RICOH Modification Bulletin

Model: PRIPORT GOLD		Date: 30-Jun-97	No: 01
Modified Article: Parts Catalog		Prepared by: 	
From: Priport Service Planning Section		H. Kokubo	
Classification: <input checked="" type="checkbox"/> Parts catalog correction <input type="checkbox"/> Vendor change <input type="checkbox"/> To meet standards <input type="checkbox"/> To facilitate assembly <input type="checkbox"/> To improve reliability () <input type="checkbox"/> Part standardization <input type="checkbox"/> Other ()			
Model Name: Ricoh VT2250/VT2240, Gestetner 5329(L), RexRotary 1254(L), nashuatec CP329(L), ABDICK 6560, SVN 3250DNP

Model: PRIPORT GOLD		Date: 15-Sep-97	No: 2
Modified Article: Thermal Head		Prepared by: 	
From: Priport Service Planning Section		H. Kokubo	
Classification: <input type="checkbox"/> Parts catalog correction <input checked="" type="checkbox"/> Vendor change <input type="checkbox"/> To meet standards <input type="checkbox"/> To facilitate assembly <input type="checkbox"/> To improve reliability () <input type="checkbox"/> Part standardization <input type="checkbox"/> Other ()			
Model Name: Ricoh VT2250/VT2240, Gestetner 5329(L), RexRotary 1254(L), Nashuatec CP329(L

30. DRIVE SECTION 1 (C226), PAGE 66

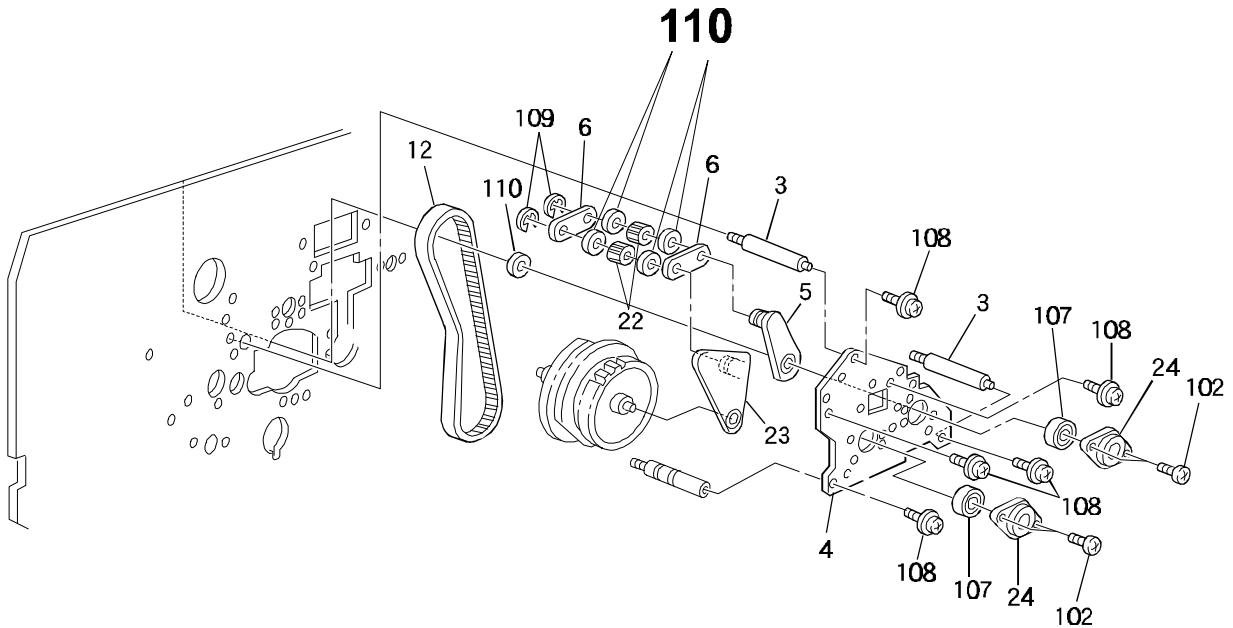
Add index number 110 (four washers) as shown below:

33. ELECTRICAL SECTION (C226), PAGE 72

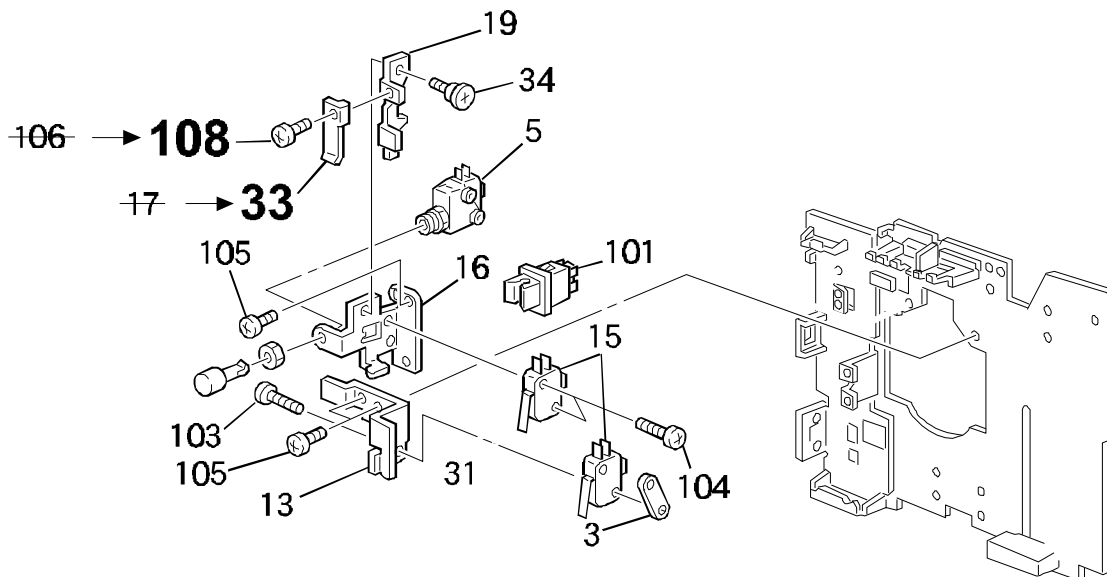
Correct index numbers 106 and 17 as shown below:

- 106 → 108
- 17 → 33

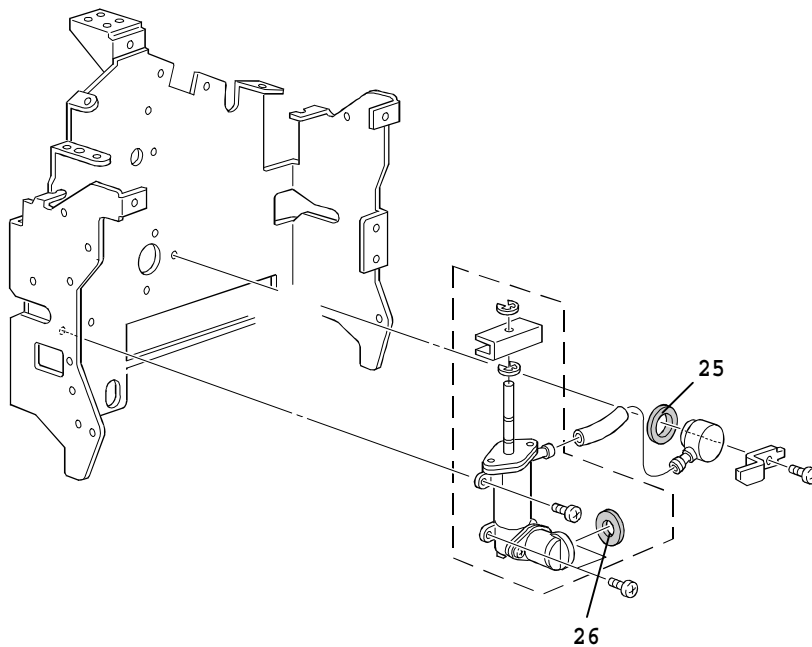
Please correct your parts catalog as follows.

Incorrect Part Number	Correct Part Number	Description	Qty	Int	Page	Index
C2004826	08080021	Rubber Ring	1	-	45	25
C2004827	C2004826	Pump Rubber	1	-	45	26

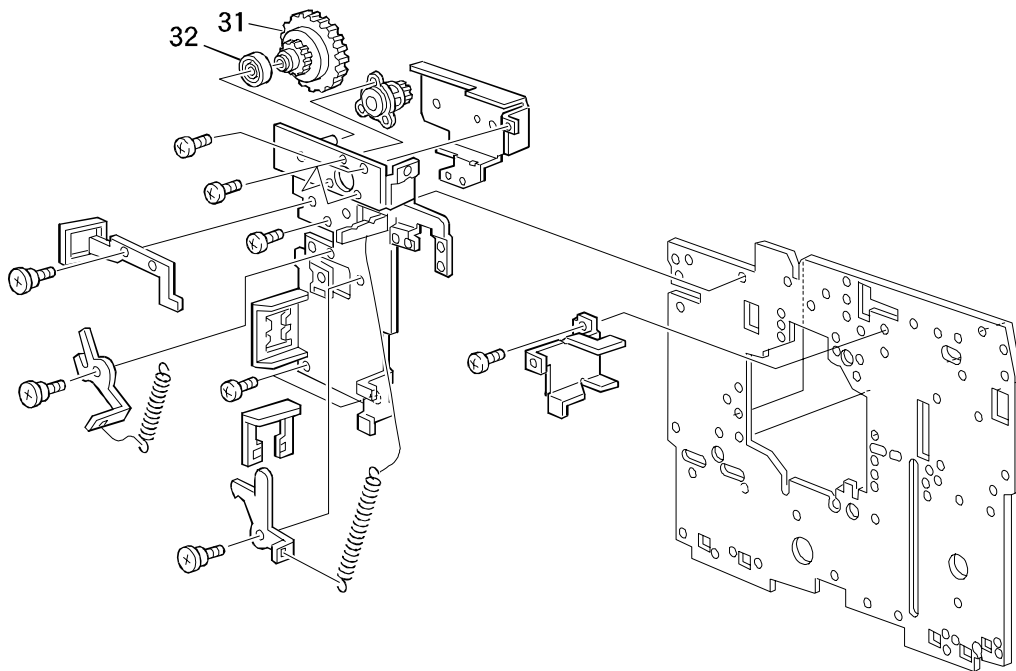
The width of the oil damper gear (scanner) has been increased by 2 mm to reduce the load on the gear wheel and ensure the gear is not damaged.

Old part number	New part number	Description	Q'ty	Int	Page	Index
H5213117	H3073117	Gear – oil damper	1	X/O as a set	77	31
	H5223118	Collar – oil damper	1		77	32
H5213118	H3073117	Gear – oil damper	1	X/O as a set	77	31
	H5223118	Collar – oil damper	1		77	32

Note: Replace the oil damper gear and collar **together as a set**
